SUBJECT: Response to Request for Additional Information (RAI) on Proposed Revision to the Safety Evaluation for the Spent Fuel Storage Rerack at Fort Calhoun Station (FCS) Unit No. 1 (TAC No. M91954)

OMAHA PUBLIC POWER DISTRICT  
FORT CALHOUN STATION UNIT NO. 1

**"Responses to Request for Additional Information  
on the Proposed Revision to the Safety Evaluation Report  
for the Spent Fuel Storage Reracks"**

Figure 1

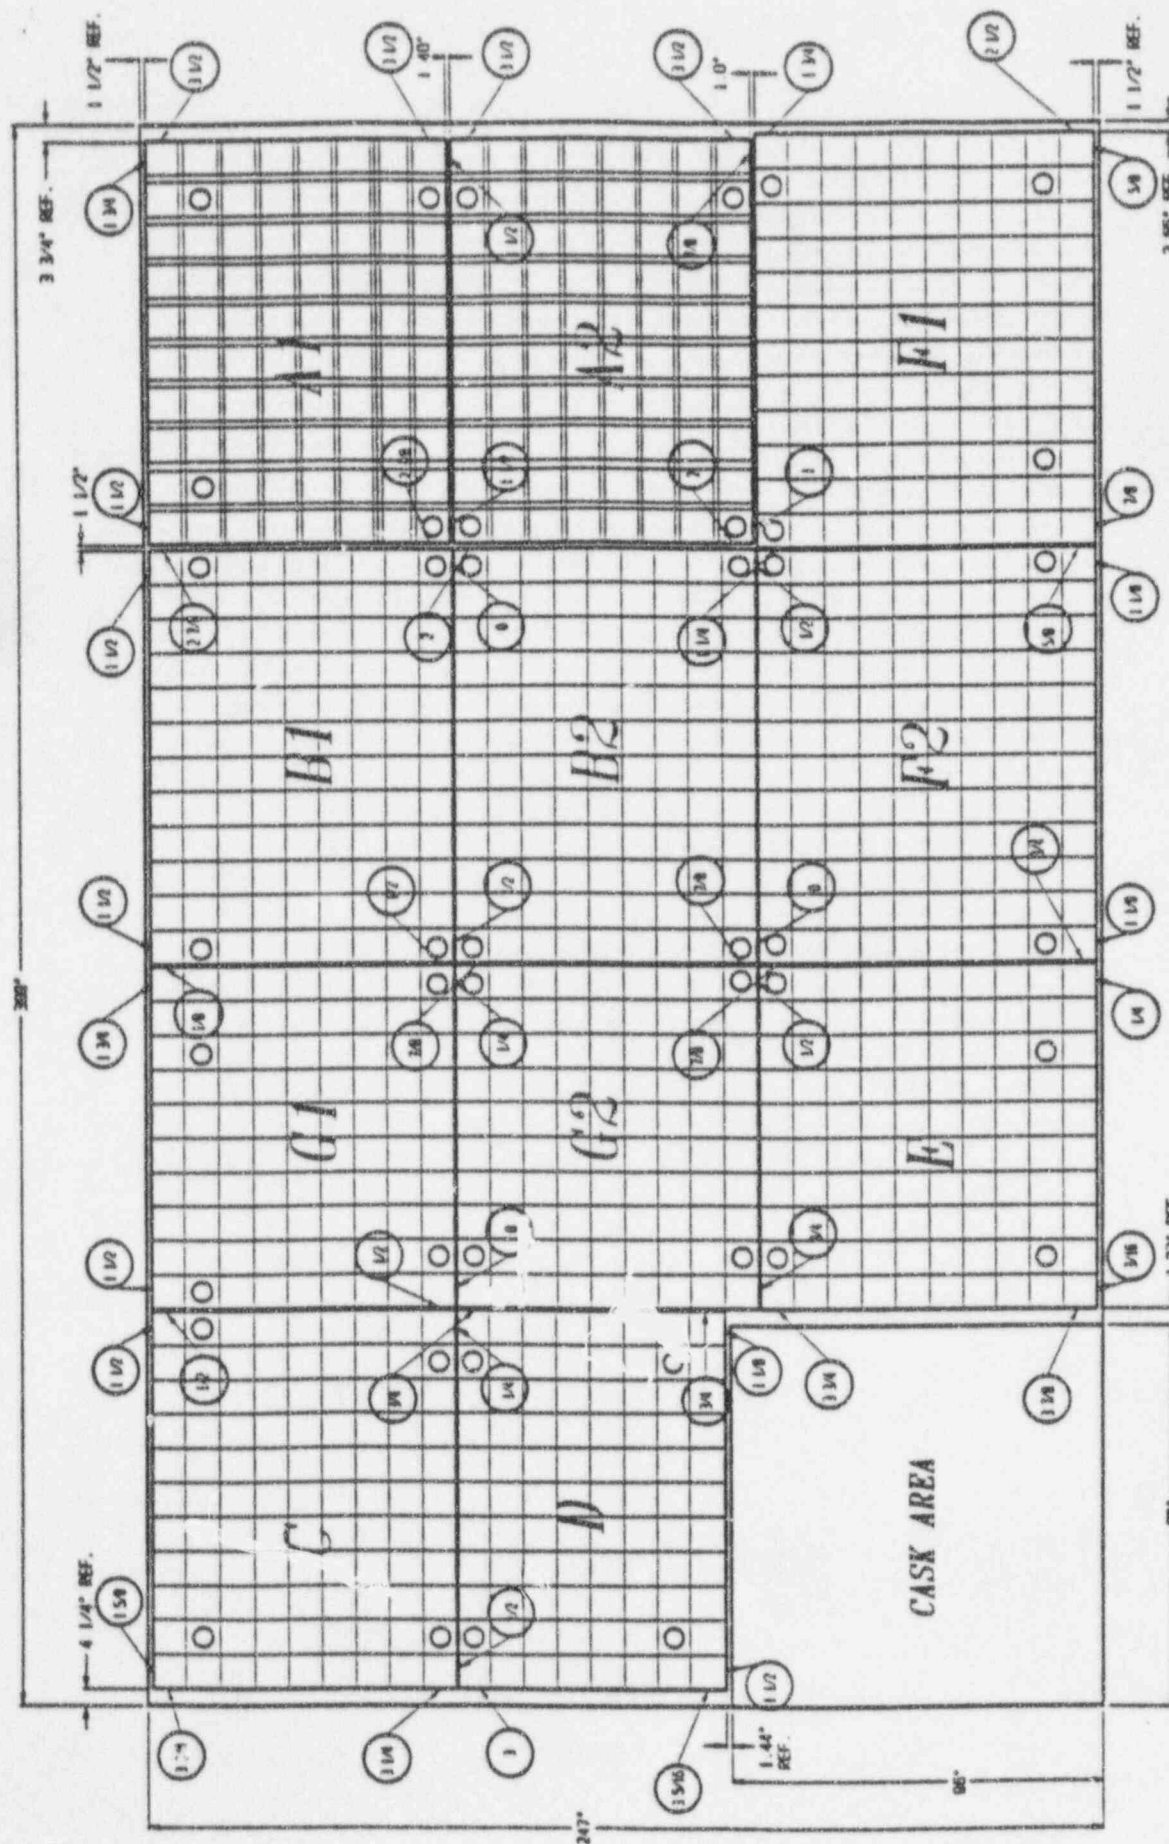
**Provide the clearances between the racks and between the racks and the spent fuel pool walls used in the original and re-analysis in a tabular form.**

The attached sketch of the FCS Unit 1 pool layout (Figure 1) shows the "as built" rack-to-rack and rack-to-wall gaps as well as the design basis gaps. The "as built" gap measurements are circled in the sketch and were measured from the most protruding points of the bumper bars. The design and as-installed average clearance between racks and between racks and walls (excluding bumper bars) are shown in Table 1.

\* The as-installed gap size is taken as the average of two measurements at rack top excluding 3/16-inch bumper bars (see Figure 1). The values in parentheses are the nominal design basis gaps.
